SAFETY EVALUATION BY THE OFFICE OF NEW REACTORS  
RELATED TO EXEMPTION AND AMENDMENT NO. 7  
TO THE COMBINED LICENSE NO. NPF-91  
AND LICENSE NO. NPF-92  
SOUTHERN NUCLEAR OPERATING COMPANY, INC.  
GEORGIA POWER COMPANY  
OGLETHORPE POWER COMPANY  
MUNICIPAL ELECTRIC AUTHORITY OF GEORGIA  
CITY OF DALTON, GEORGIA  
VOGTLE ELECTRIC GENERATING PLANT UNITS 3 AND 4  
DOCKET NOS.: 52-025 AND 52-026

By letter dated October 17 2012, (Agencywide Documents Access and Management System (ADAMS) Accession No. ML122960644), Southern Nuclear Operating Company (SNC/Licensee) requested that the U.S. Nuclear Regulatory Commission (NRC/Commission) amend the combined licenses (COLs) for Vogtle Electric Generating Plant Units 3 and 4 (VEGP), COL Numbers NPF-91 and NPF-92, respectively. The proposed license amendment request would depart from the updated Final Safety analysis report (UFSAR) Tier 1 and Tier 2 material by making changes to the Turbine Building (TB) structures and layout.

Figure 1: AP1000 DCD Figure 3.7.2-22, 3D SASSI Model with Adjacent Structures

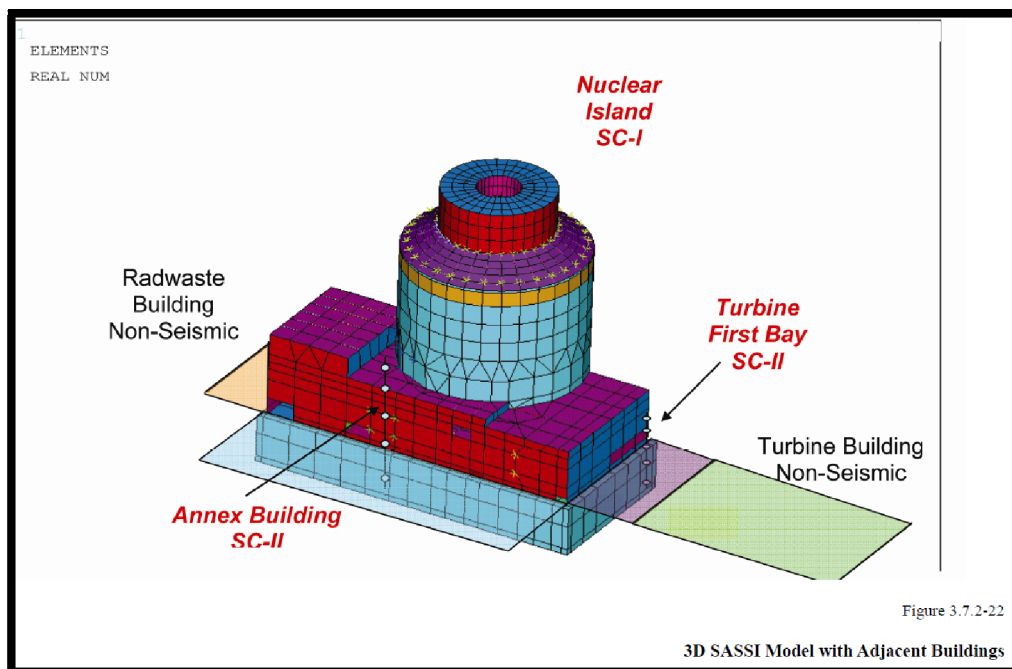
The TB first bay is designed for the AP1000 Certified Seismic Design Response Spectra (CSDRS) and the envelope of responses of the six soil profiles described in Subsection 3.7.1.4 of the UFSA). The Vogtle site-specific SSE design response spectra (DRS) are the site-specific ground motion response spectra (GMRS) determined in Early Site Permit SSAR Subsection 2.5.2.6. These response spectra are determined in the free-field on the ground surface. The seismic analysis of the TB first bay is described in Section 3.7.2.8.4 of the UFSAR. The seismic analysis is performed using SASSI, a soil-structure interaction analysis code. The NI is idealized as a 3D finite element model, and the seismic Category II buildings are modeled as simplified lumped-mass and beam models. The model used for the SSI analysis of the AP1000 standard plant structures is shown in Figure 1 below. Seismic Category II structures, like the TB first bay, are designed so that the SSE does not cause unacceptable structural failure or interaction with adjacent seismic Category I structures. In the case of AP1000, Seismic Category II structures are analyzed and evaluated in the same manner as seismic Category I structures. The same methodology is applicable to Vogtle since the Vogtle Combined Operating License Application incorporated by reference relevant portions of the AP1000 Design Certification Document (DCD) Section 3.7 and DCD Section 3.8 in its entirety.

While the more significant engineering design issue relates to the structure-soil-structure interaction (SSSI) effect of the AP1000 NI seismic response on adjacent building seismic response, the opposite effect was also analyzed. The dynamic effects of adjacent seismic Category II structures on the AP1000 NI were analyzed as part of the AP1000 seismic analysis described in UFSAR Section 3.7. These analyses were performed with and without adjacent structures and showed that the SSSI effects of adjacent structures on the NI were insignificant. The staff's review of these analyses is described in Section 3.7 of the AP1000 FSER (Reference 5).

**Figure 2: Turbine Building Layout**

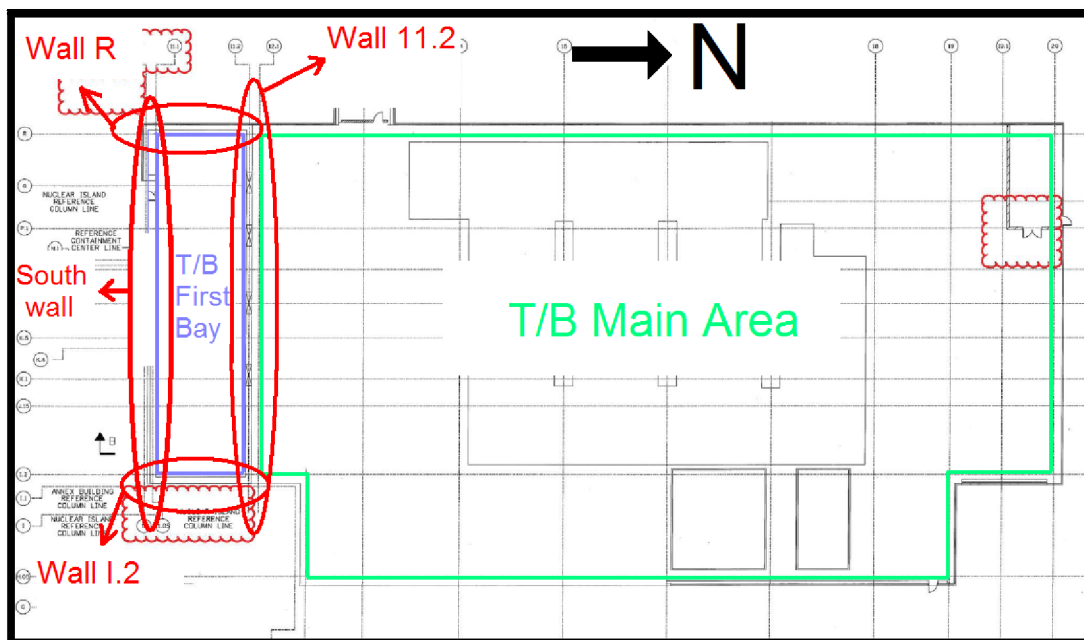
In the LAR, Enclosure 1, page 10, the licensee describes that as a consequence of changes to the TB main area, the height of the TB first bay will be increased from elevation 161'-0" to elevation 169'-0" to allow for installation of blowout panels. This TB first bay wall elevation change further involves increasing the thickness of the first bay walls adjacent to Column Line I.2 and adjacent to Column Line R, shown in red on Figure 2 below. Enclosure 1, page 10, states that the licensee's analysis demonstrates that increasing the thickness of walls R and I.2 from 2 feet to 3 feet, will structurally compensate for the increase in height.

To assess the impact of the design changes on the seismic response of the TB first bay, the licensee provided SSI analysis results comparing the site-specific response to the standard

plant design basis. LAR Enclosure 5 provides comparisons of TB first bay seismic analysis results. These results showed that the site-specific demands for the modified TB were enveloped by the AP1000 floor response spectra with the exception of a narrow frequency band. The site-specific spectra indicate a minor exceedance (<10%) in the low frequency range (0.5-0.6 Hz). To address this exceedance, the licensee stated that there will be no SSC's with resonant frequencies in that frequency range, so no equipment should be affected. The licensee also stated that displacements, soil pressures, and basemat stresses are still within approved design values.

The staff performed a review of Enclosure 5 results and found the seismic model and analysis methods to be consistent with UFSAR Section 3.7 and therefore acceptable. Staff's review of the response spectra comparisons in LAR Enclosure 5 finds that the AP1000 standard plant design response spectra envelope the site-specific analysis that included the TB design changes. The staff performed a review of the low-frequency exceedances and finds that there are no safety-significant components with resonant frequencies in this range. This conclusion is consistent with that described in staff's FSER (Section 3.7) for VEGP Units 3 and 4.

Staff's review of the TB first bay design changes finds that the changes will be performed in accordance with accepted code provisions ACI-349 and AISC/N690 and that the design remains enveloped by the AP1000 standard plant design response spectra in the frequency range significant to structural design (greater than 3 Hz). On this basis, the staff finds the changes to the TB first bay to be acceptable.
